# Christofferson Ranch

Development Agreement

# Concept Plan

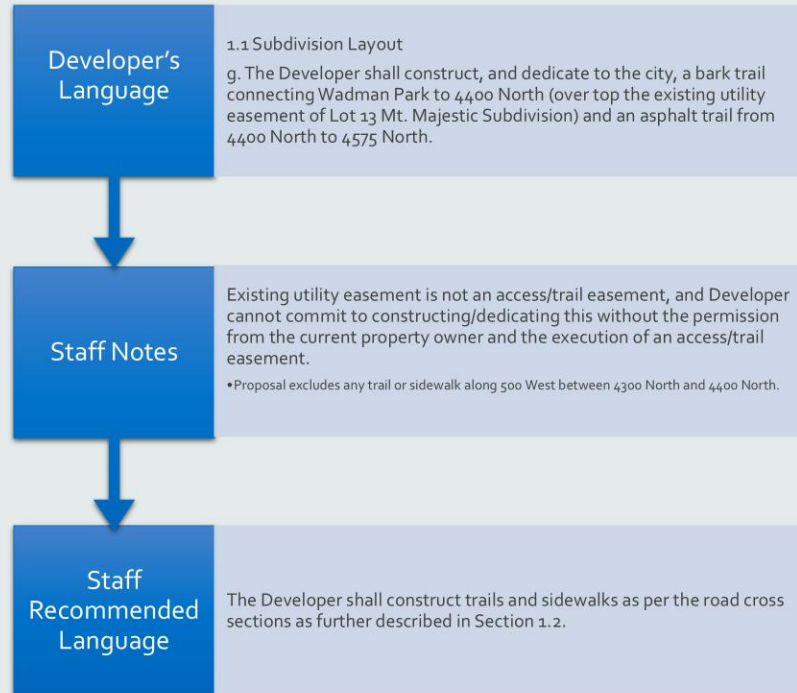
Issue:  
Existing Easement  
is not indicated for  
a trail

Developer  
Changes:  
Will obtain trail  
easement from  
property owner

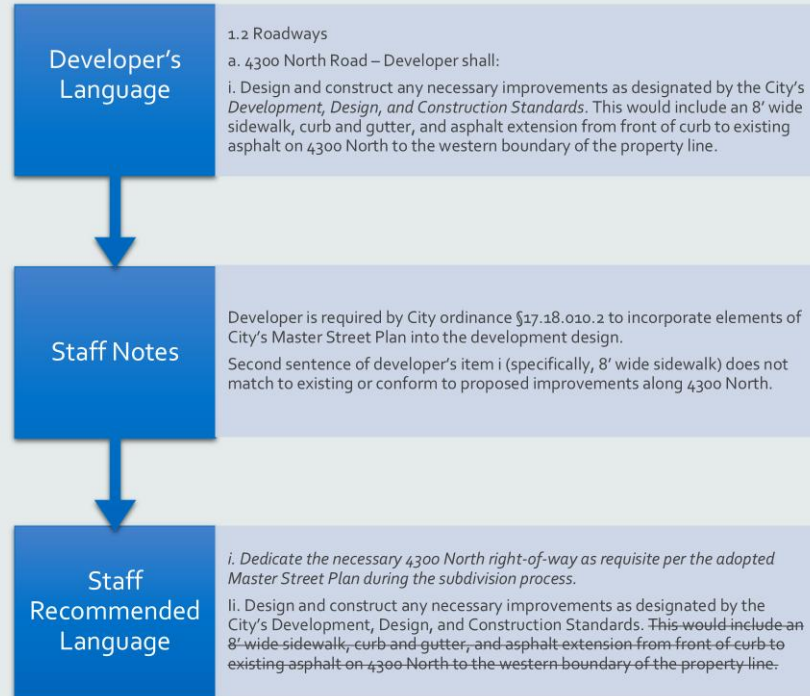
Developer's Language	1.1 Subdivision Layout h. Sensitive Lands Protection: The subdivision layout shall take into account the surrounding environment, particularly sensitive lands, wetlands, and ecologically sensitive areas.
Staff Notes	Items listed in City ordinance §18.35.030, "natural and scenic environmental features including wetlands, drainage courses, ridge line, slopes, trees, rock outcroppings, natural trails, and other special features," are seemingly <u>not</u> being provided protection.
Staff Recommended Language	None

Issue:  
Does proposed subdivision meet objectives of a "cluster" development

Developer Changes:  
None

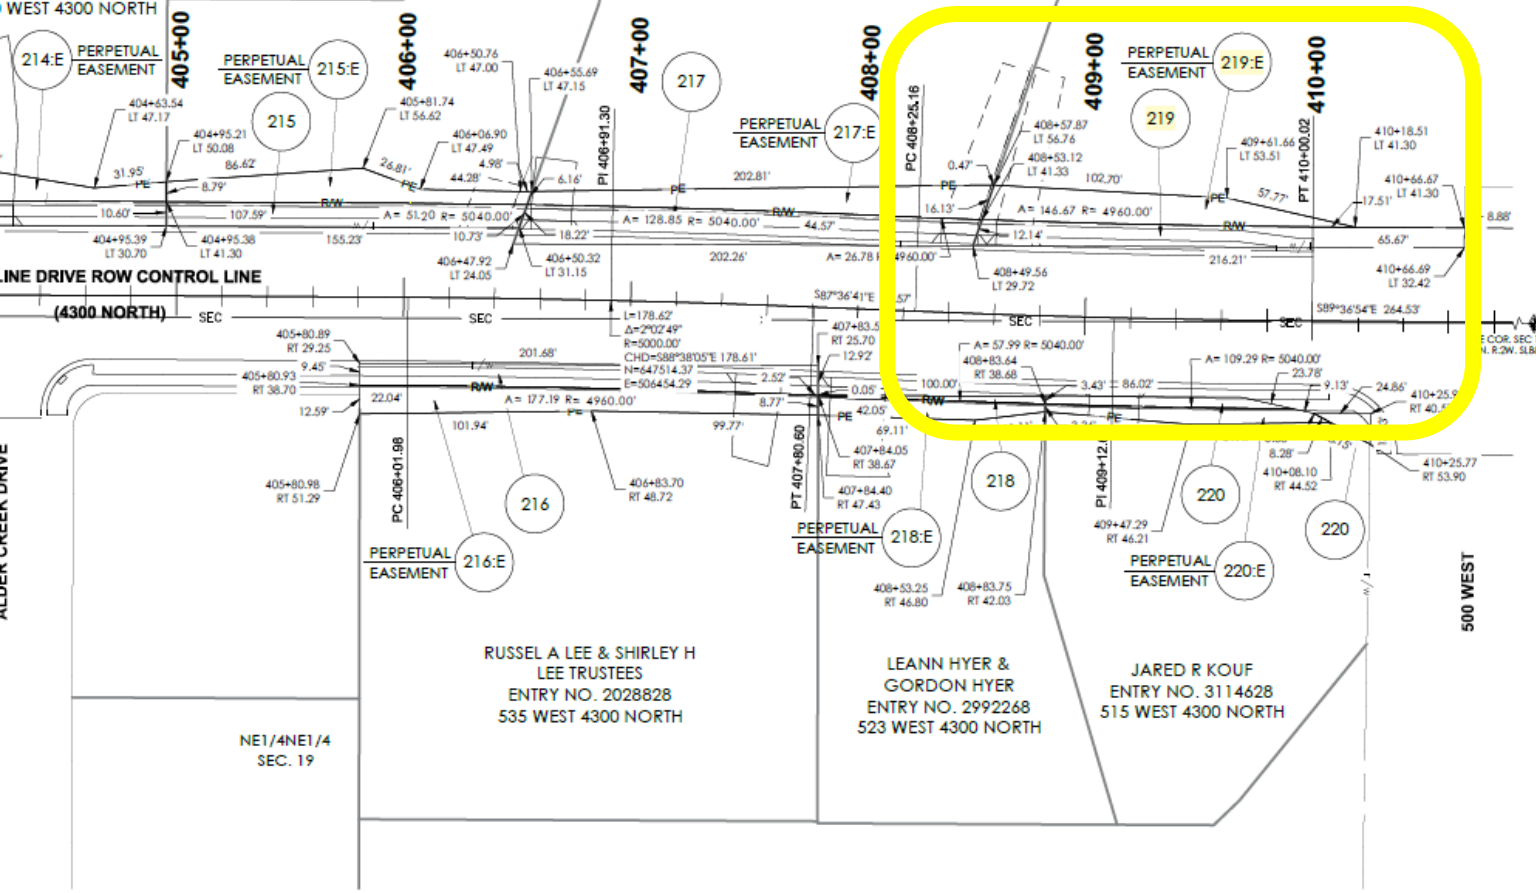
Easement needed for continuation of 4300 North.

Extra unnecessary language.

Developer Changes:  
Provided proof PVC has obtained such R.O.W. easement.

Unnecessary language removed.

Standard Road Section  
(PVC Public Works Standards)  
66' Width for Minor Collector

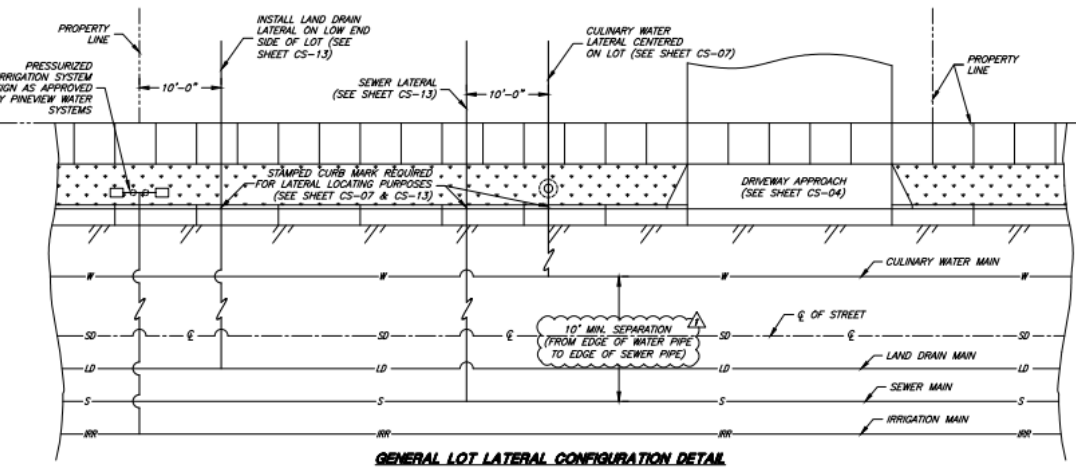
Developer's width of 500 West does not conform to the City's Master Street Plan; therefore, it is in violation of City ordinance §17.18.010.  
Staff recommends not including subparagraphs a and b as this detail is provided in proposed Exhibit C.  
Staff recommends installation of the trail the full length of 500 West, from 4300 North to 4575 North; the width of the trail to be wider than a standard sidewalk, as it is intended to be a multi-use trail and there is only trail on one side of the road. Subparagraph iii may be struck out entirely as the trail standards are contained in the exhibit.

Issues:  
Rural road cross-section not adopted.  
60' width does not meet master street plan.

a. Dedicate a 66-foot wide right-of-way extending from 4300 North Road to 4575 North Road.  
b. Design and construct a 66-foot wide rural roadway as detailed in Exhibit C.

Developer Changes:  
60' "standard" road section, with sidewalk on only one side.

**17.18.010 Relation to Adjoining Street Systems:**

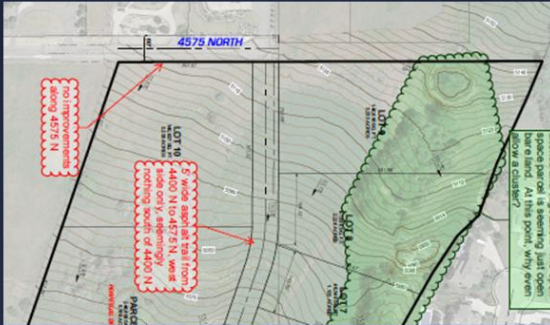
Staff requests 60' R.O.W. to be dedicate to accommodate connectivity (17.18.010).

None/No R.O.W. dedication.

Indicates alternate proposal for adjacent property owner.

Concern about Green belt eligibility.

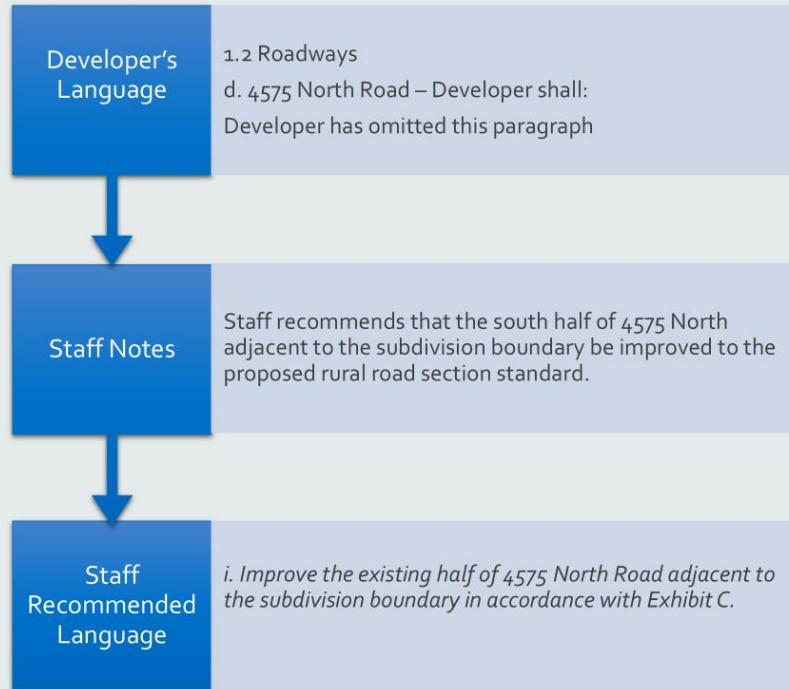
Issue:  
Developer omitted paragraph requiring improving the existing half of 4575 N adjacent to subdivision boundary.

Developer Changes:  
None – paragraph remains omitted from DA.

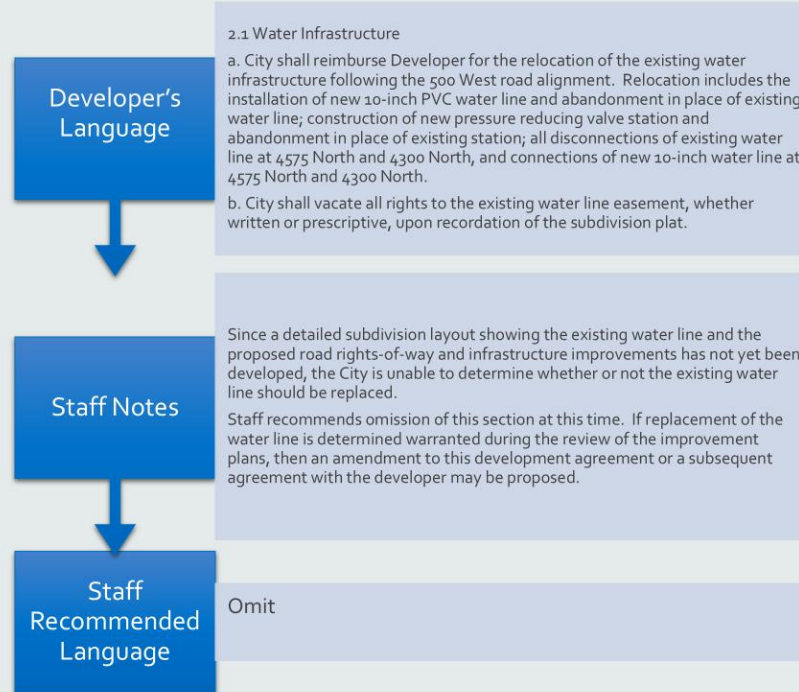
- Regarding subparagraph a.ii – Ordinance §18.35.040 G states that open space shall be preserved for “recreation and/or open space”; no provisions for agricultural, education, or building purposes are listed in the ordinance.
- Regarding paragraph c – City has not yet confirmed with Pineview Water System the irrigation requirements/restrictions. Subparagraph iv is not binding via this development agreement.

Open space included uses not allowed by ordinance.  
Pineview water has not confirmed irrigation requirements/restrictions.  
Wetlands to be protected with easements.

Removed uses not allowed by ordinance.  
Indicates a will-serve letter will be obtained from Pineview water.  
No added language regarding easements for wetlands.

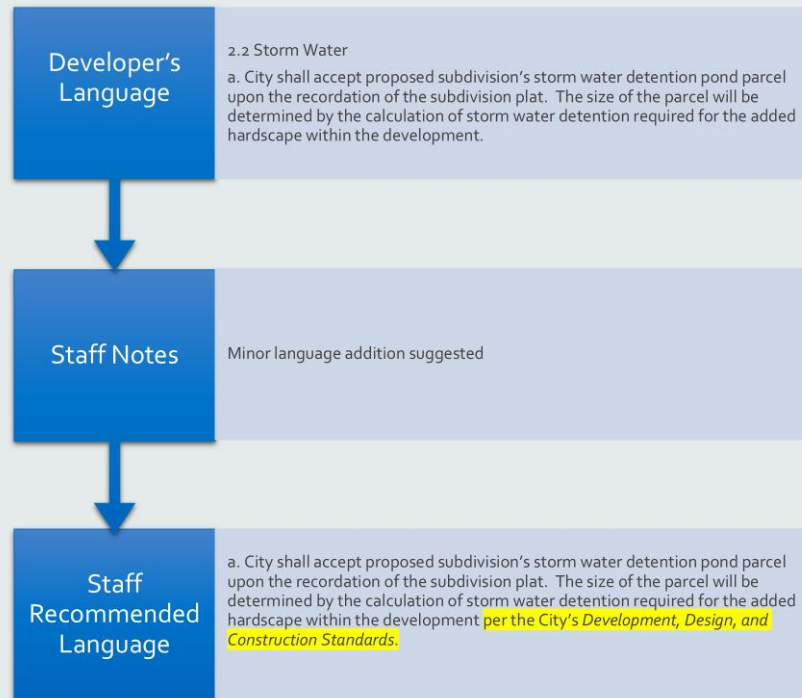
The City is unable to determine if the existing water line needs to be replaced.

Developer Changes:  
Language added that reimbursement to developer for new water line will only occur if/when the City determines replacement is necessary.
